Design of a Community Center in Batam Center Through Social Condenser Design Approach

Final Architectural Design Studio
International Undergraduate Program in Architecture

Mohd Rhafie Nadhif Nureski
21512164

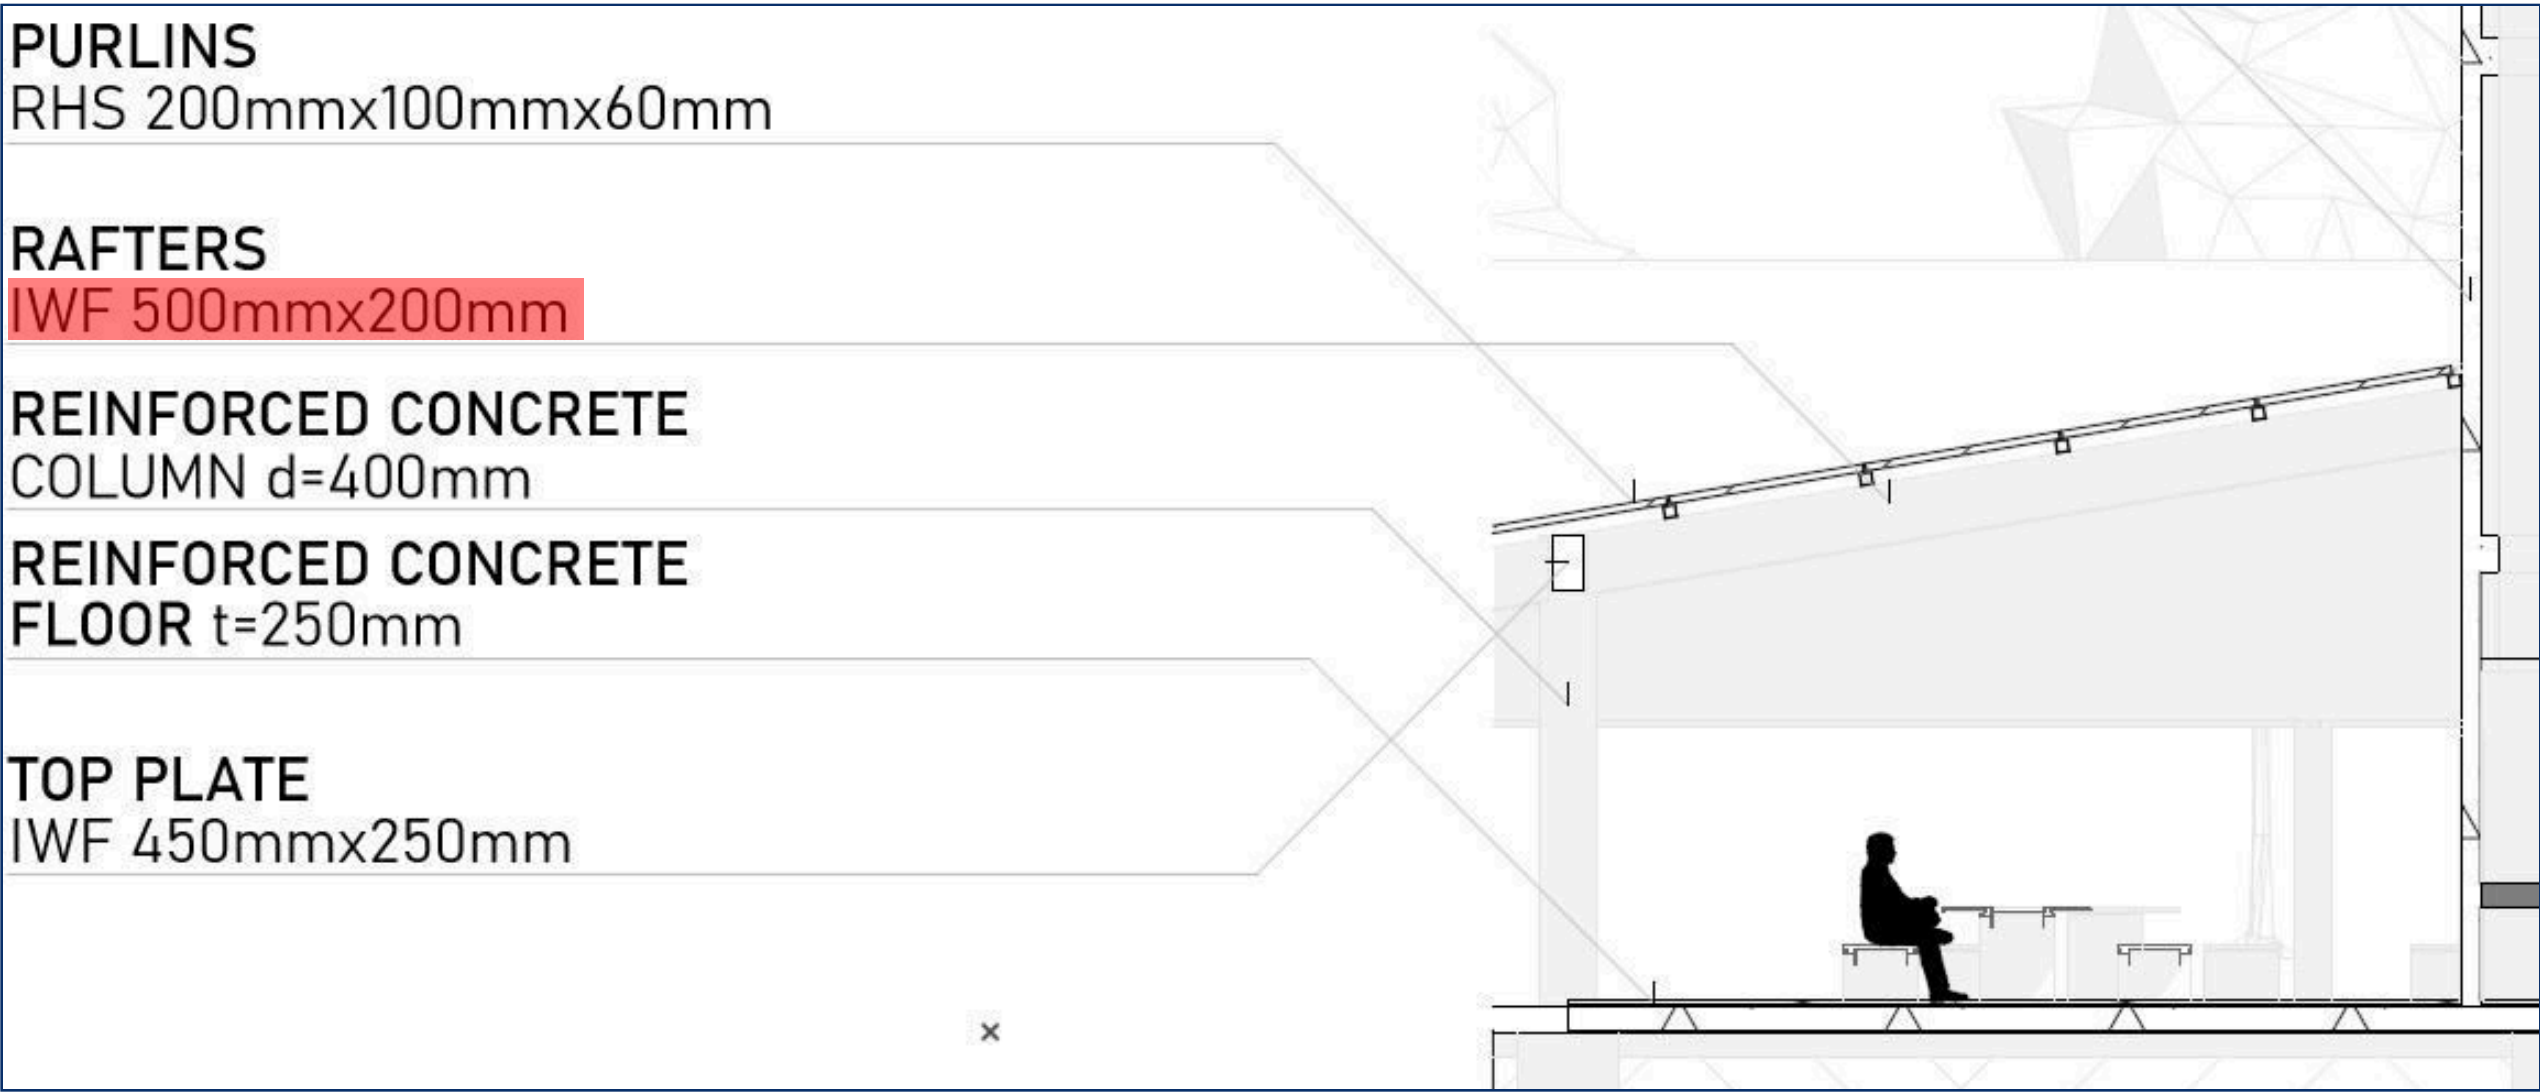
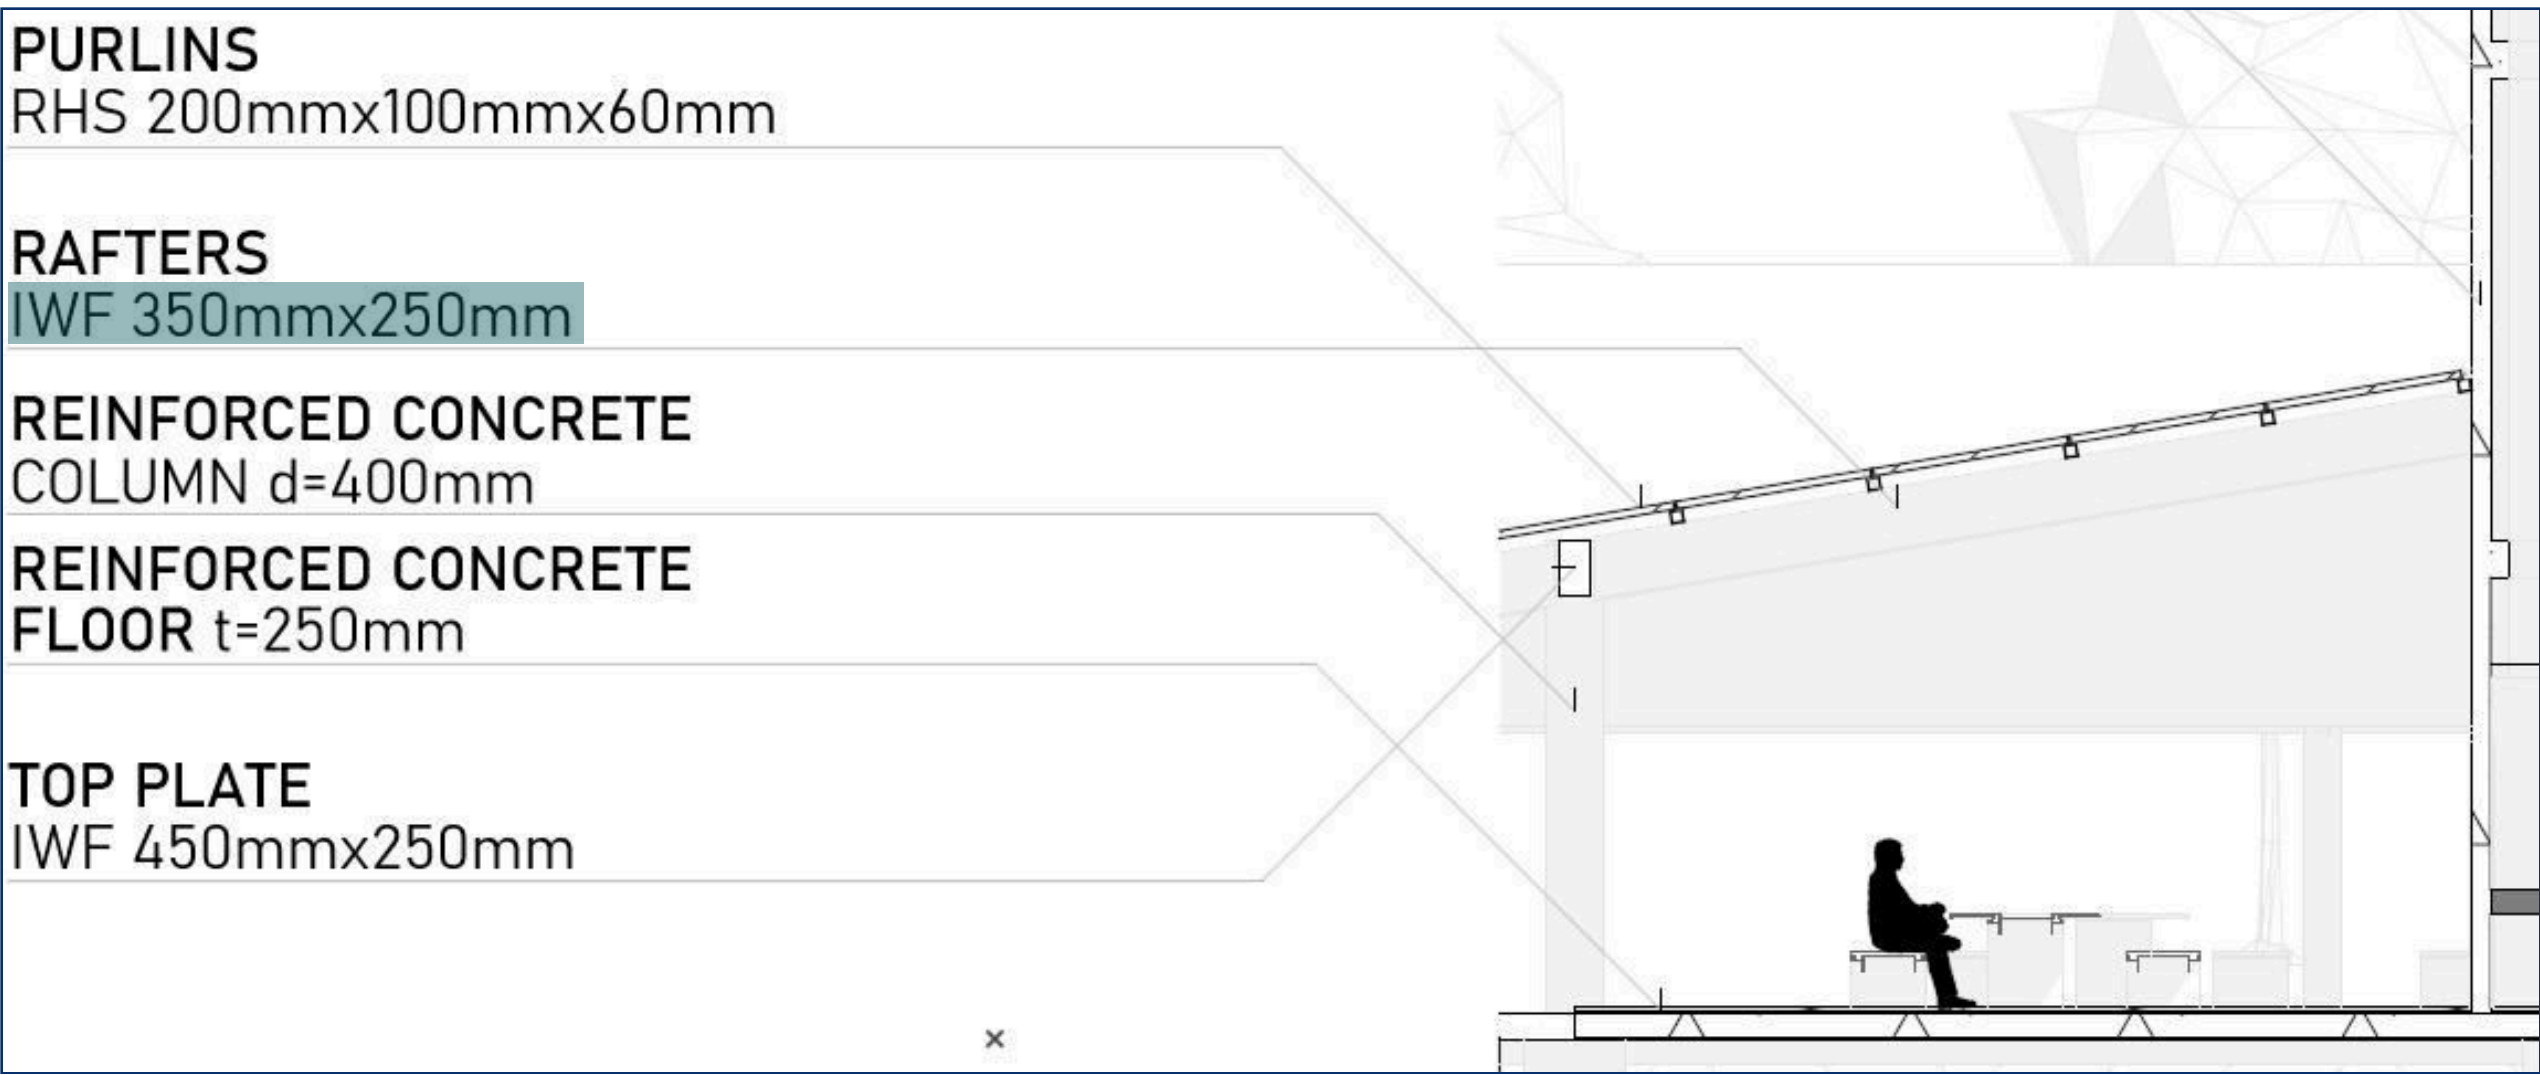
Comment from Jury 2
Dr. Ar. Yulianto Purwono Prihatmaji, ST., M.T., IPM., IAI.
“Dimension for the rafter is too big”
